## CITY OF ALBUQUERQUE

RE: Lot 13 Block 9 Unit 22, S.A.D. 228
Volcano Cliffs Subdivision
6411 Petirrojo Rd. NW
Grading and Drainage Plan
Engineers Stamp Date 7/28/2020 (D10D003Q13)

Based upon the information provided in your submittal received 7/27/2020, this plan is approved for Grading Permit.

SOLIS, JAVIER - G & D PLAN

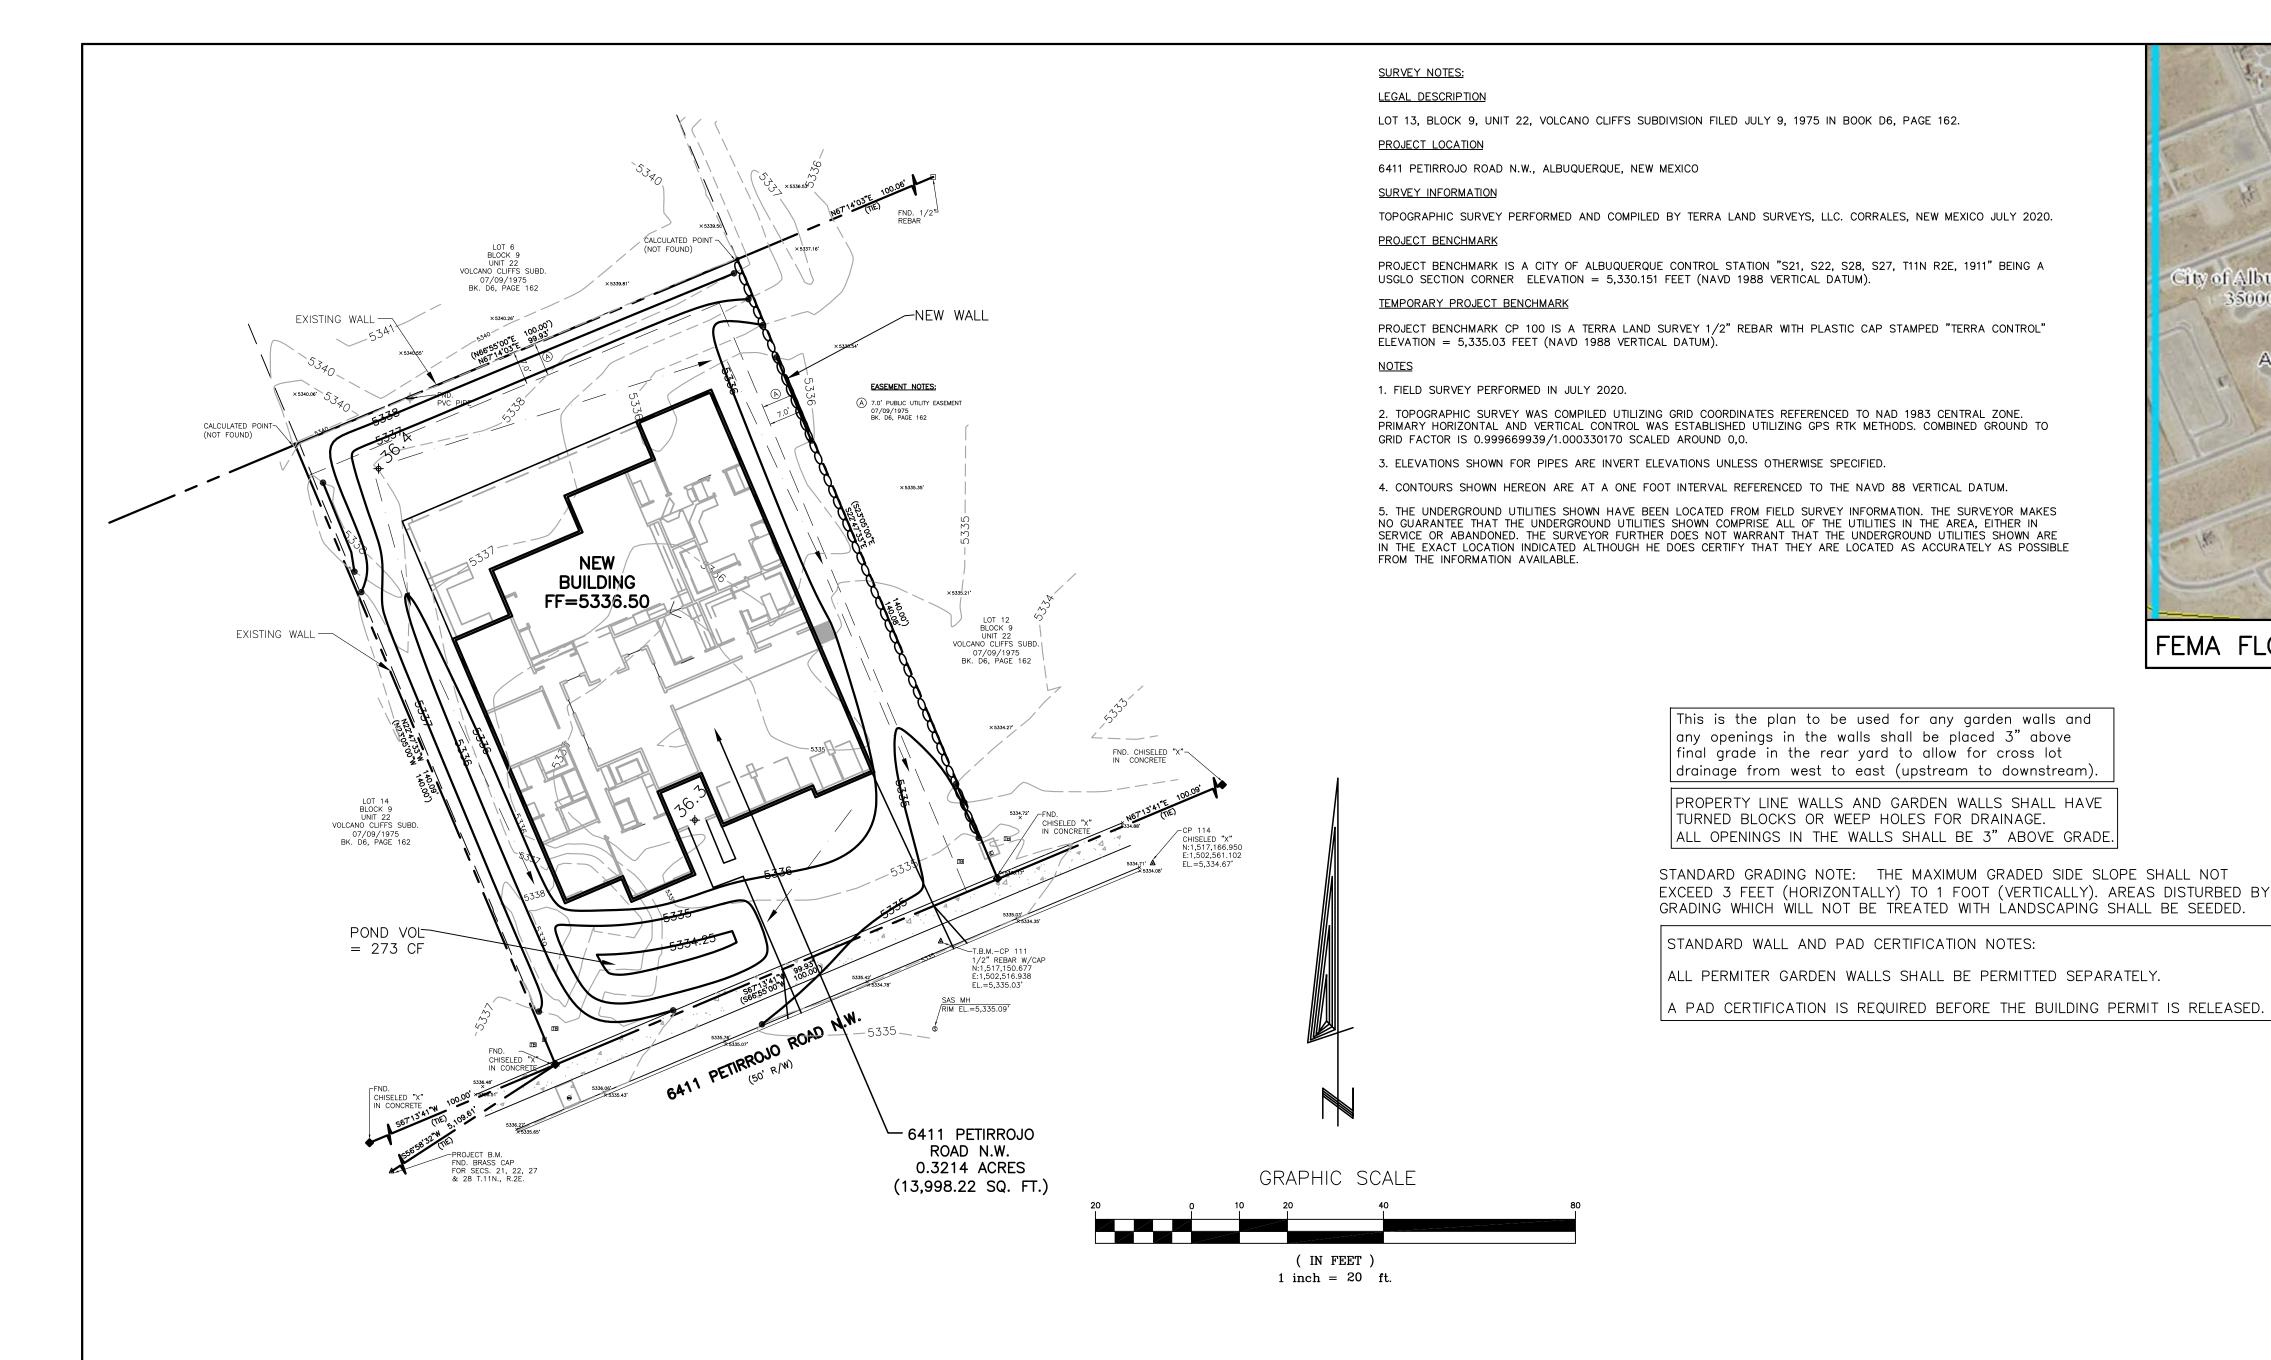
Prior to Building permit approval a Pad Certification will be required, provided by the Engineer or a registered Land Surveyor.

Reiterate to the Owner/Contractor that a separate permit for a garden/retaining wall must be obtained, with the approved G&D plan dated 7/28/2020.

Prior to Certificate of Occupancy release, Engineer Certification per the DPM checklist of this plan will be required.
